Final Safety Evaluation

Related to the
Long Mott Energy, LLC,
Construction Permit Application for
the Long Mott Generating Station

Completed: October 2026

Figure 2.5-1 – PGA Total Mean Hazard and 1 Hz Total Mean Hazard

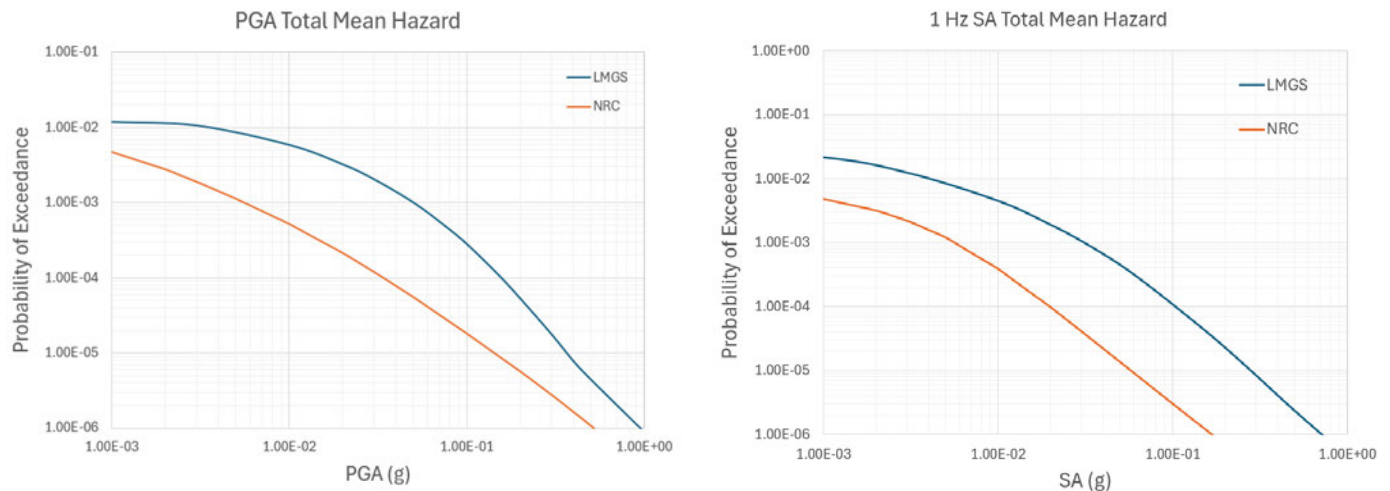
across the entire range of acceleration values (Figure 2.5-1). The difference in hazard between the applicant's hazard results and the NRC staff's results is attributed mainly to the inclusion of EFFZ in the applicant's analyses.

Overall, NRC staff finds the applicant's PSHA model, the inputs and modifications, as well as the hazard results evaluation technically reasonable and supported by the applicant's analyses and literature review.

Figure 3.1-1 Initial DLOFC peak temperature comparison

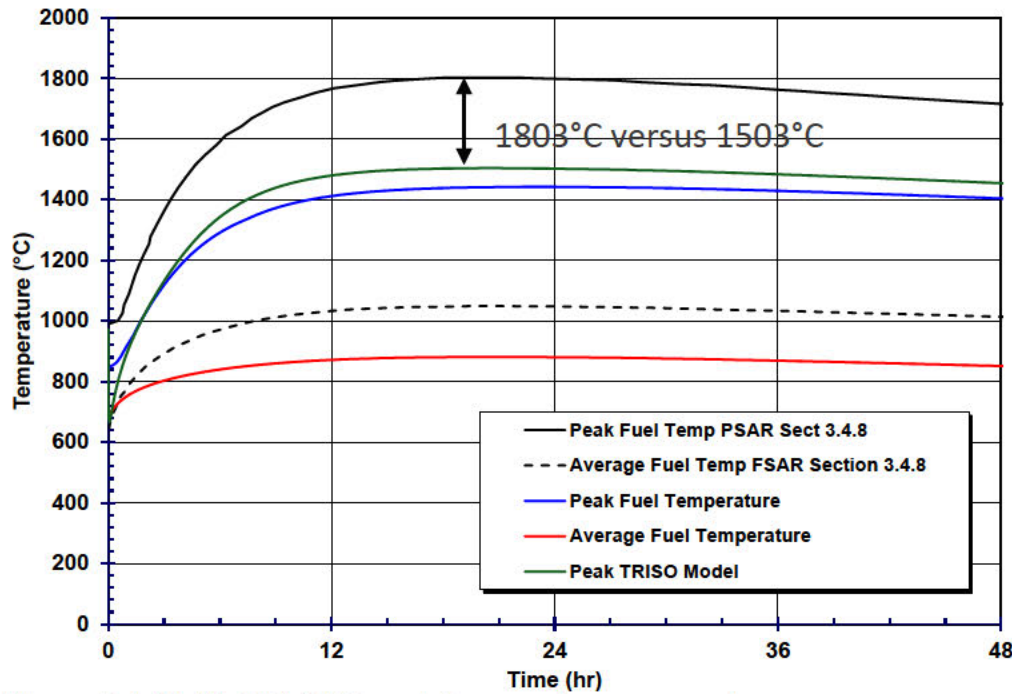
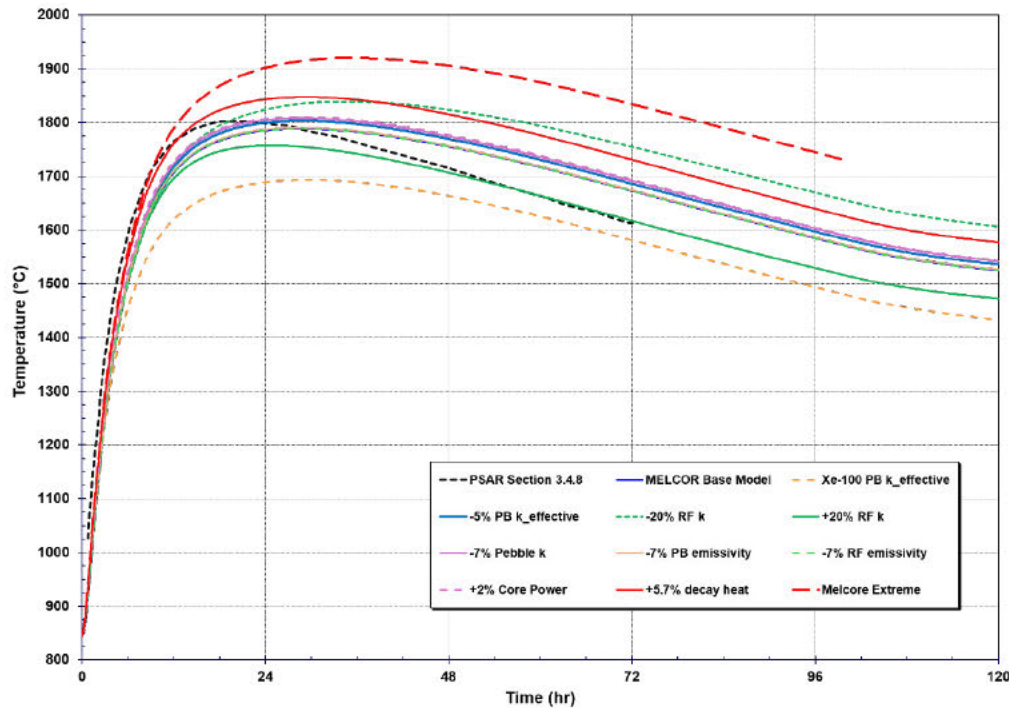
Iterative confirmatory calculations were conducted to verify LMEs temperature calculations. Initial MELCOR confirmatory modeling showed lower temperatures for accident scenarios, including the DLOFC. The differences were traced by the NRC staff to the effects of neutron damage on graphite and alignment of RPS signal timing, SG heat removal, and break size and flow. The MELCOR temperatures aligned with those of the PSAR following changes made to the analysis by the NRC staff upon receipt of the additional information on the range of fast

fluence irradiation in graphite and on the other parameters. Figures 3.1-1 and 3.1-2 show the initial and updated DLOFC temperature profiles for the confirmatory calculations, respectively. SE figure 3.1-2 for the updated calculation also includes PKPIRT variations.

Figure 3.1-3 Confirmatory MELCOR flow with reverse flow allowed and with reverse flow blocked

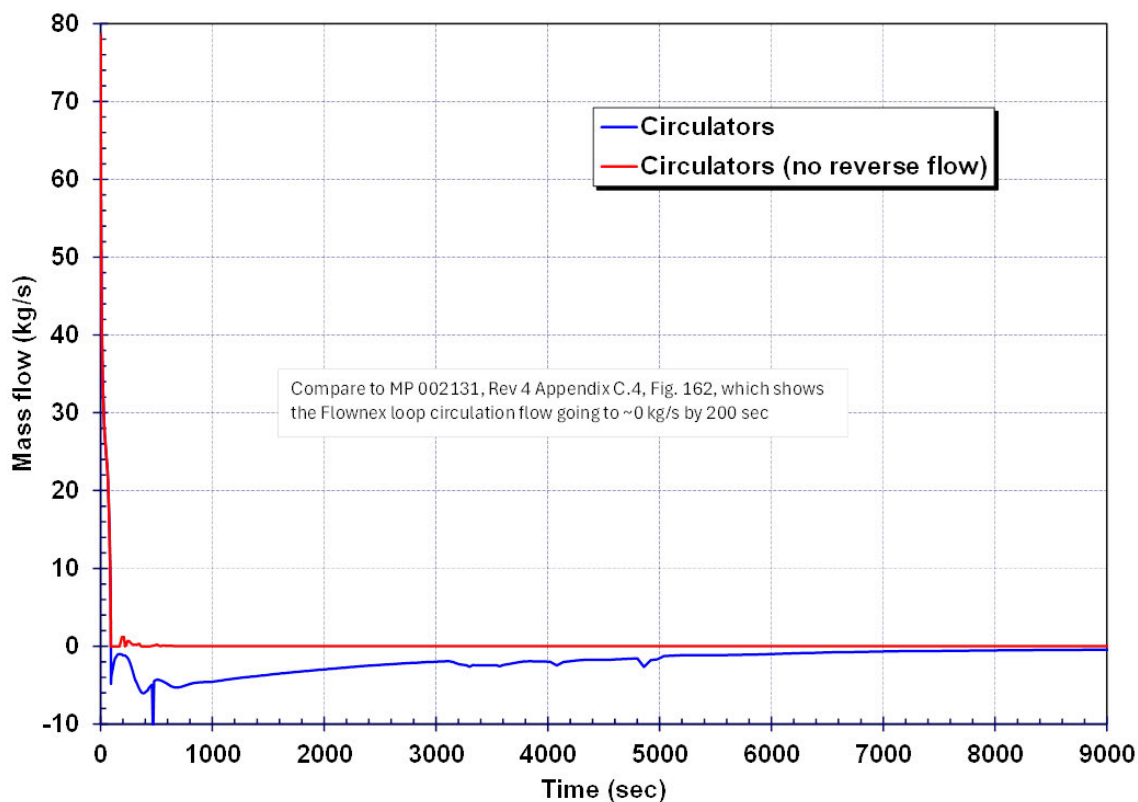
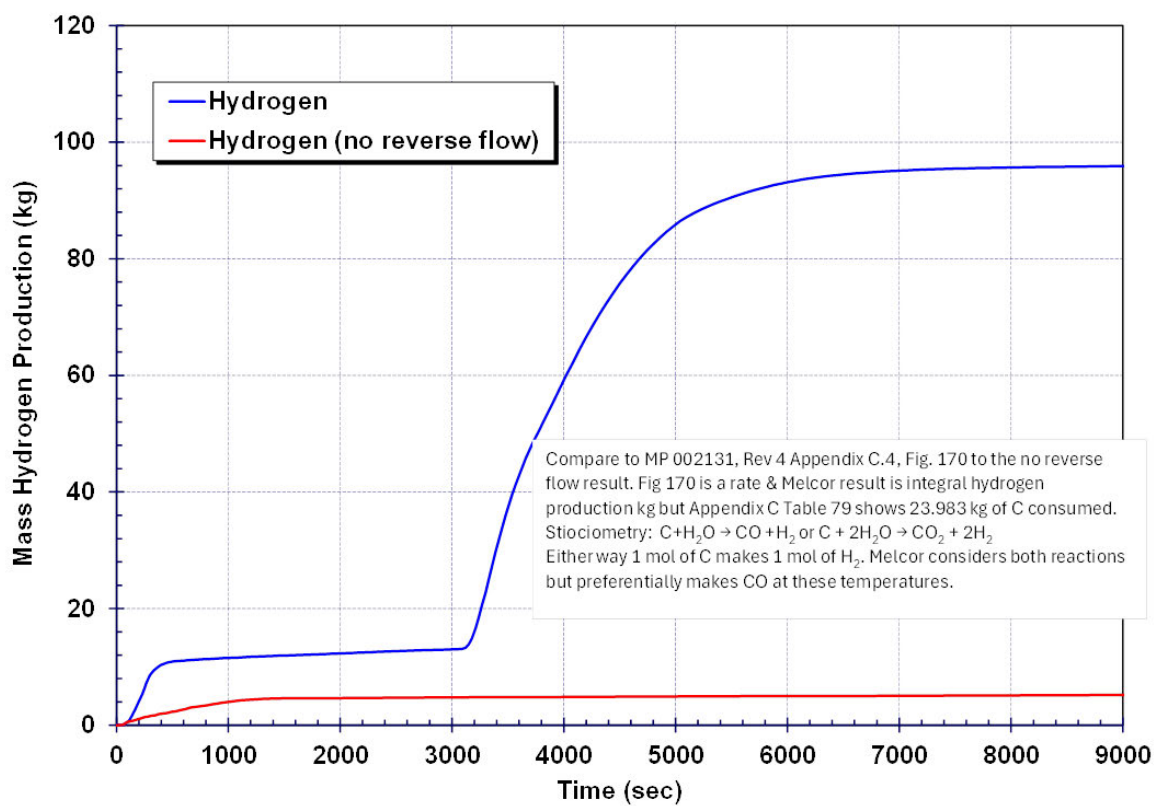
The NRC staff's initial confirmatory calculations for the SGTR DBA returned substantially more hydrogen generation than LME's calculations. The MELCOR confirmatory calculations were used to track the source of the difference to recirculation flow in the HPB loop. SE figure 3.1-3 shows the flows with and without reverse flow. SE figure 3.1-4 shows the resulting hydrogen generation for the same conditions. The confirmatory calculations predict hydrogen generation similar to that in the LME calculations if recirculation is prevented. The main difference in assumptions between the LME and NRC/SNL analyses that led to the difference was the flow resistance of the circulators: LME analyses assumed a high resistance whereas the NRC analyses assumed no resistance (i.e., circulators not modeled). The NRC staff note that this scenario involves an assumption of failure of HPB circulator check valves that would prevent this reverse recirculation flow. The assumptions are described in PSAR section 3.6.9.1.

Figure 3.6-1: Comparison of Average Fuel Temperatures

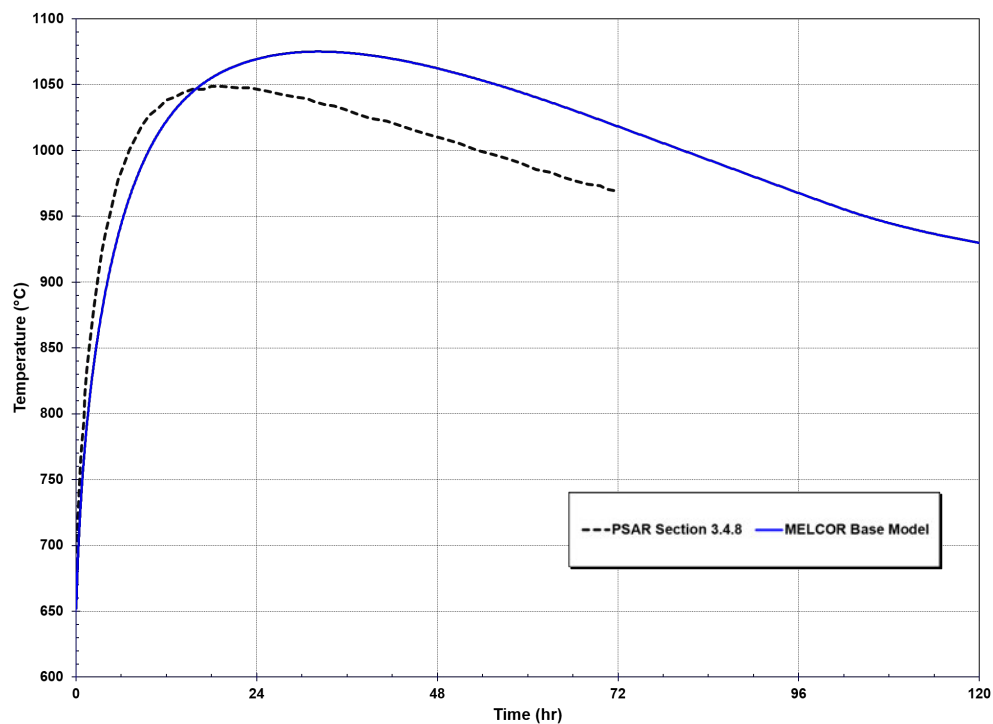
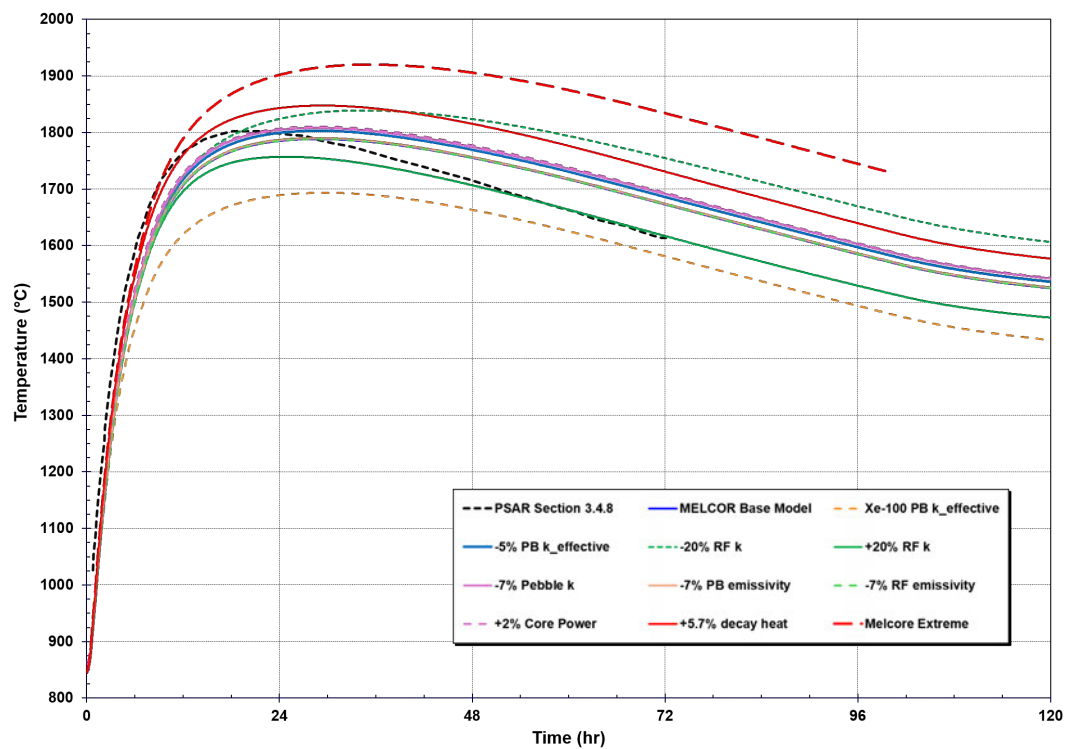
Figures 3.6-1 and 3.6-2 of this SE provide a comparison of the MELCOR calculated average and peak fuel temperatures for the DLOFC event with the values presented in PSAR section 3.4.8. The average fuel temperature is useful for characterizing overall fuel performance and estimating temperature-dependent radionuclide release. Histograms of the number of pebbles in each temperature bin were also generated to support the estimation of radionuclide releases. The maximum fuel temperature is important for identifying localized conditions that could challenge the integrity of fission product barriers, which could result in increased release. The DLOFC DBE event was chosen for comparison since it is the limiting long-term event for fuel temperatures.

Figure 3.6-2 of this SE additionally plots MELCOR results for the individual impact of the PKPIRT parameters identified in the LMGS PSAR on the peak fuel temperature. An extreme case is also plotted which combines all of the uncertainties to assess their combined impact on the peak fuel temperature. This case is similar to the 'extreme' case identified in PSAR section 3.6.2.

The results presented show a reasonably good overall agreement between the MELCOR model and the PSAR fuel temperatures. The MELCOR model predicted an overall higher average fuel temperature compared to the PSAR section 3.4.8, as shown in figure 3.6-1 of this SE. The results in figure 3.6-2 of this SE show that varying individual PKPIRT parameters did not have a huge impact on the peak fuel temperatures. The MELCOR base case predicted 1788°C for the peak fuel temperature as compared to the 1803°C prediction in PSAR section 3.4.8. Similarly, the MELCOR extreme case predicted 1920°C for peak fuel temperature as compared to the 1952°C prediction for the extreme case in PSAR section 3.6.11.

Figure 3.6-3: RPV, Core Barrel and RB Cavity Temperatures

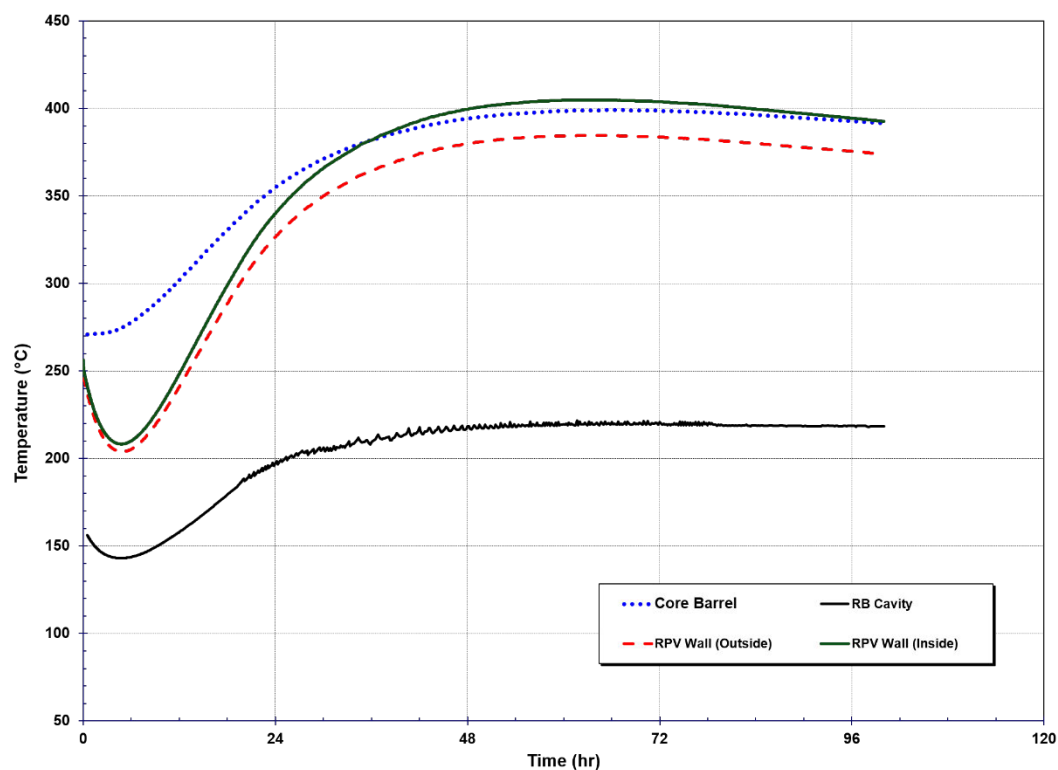
RPV and core component temperatures are important considerations in the evaluation of transient behavior. The construction code and environmental compatibility assessment for the core components include temperature design limits. Figure 3.6-3 of this SE presents the MELCOR predicted temperatures for the inner and outer RPV wall, the core barrel, and the RB cavity. The results are presented for the 'extreme' DLOFC MELCOR case, which combines all PKPIRT uncertainties to get the bounding temperatures. RPV temperatures are presented for the elevation with the highest wall temperatures, which corresponds to roughly 2m below the top of the pebble bed.

PSAR section 6.4.6 lists the design temperature for the RPV as 285°C for normal operations. There is no transient temperature limit provided in the PSAR. PSAR section 6.4.6 lists the material of construction for RPV components as SA-508, and ASME III.5 provides a code temperature limit for SA-508 as 540°C. This temperature is well above the maximum RPV wall temperature predicted for the MELCOR extreme 'DLOFC' case.
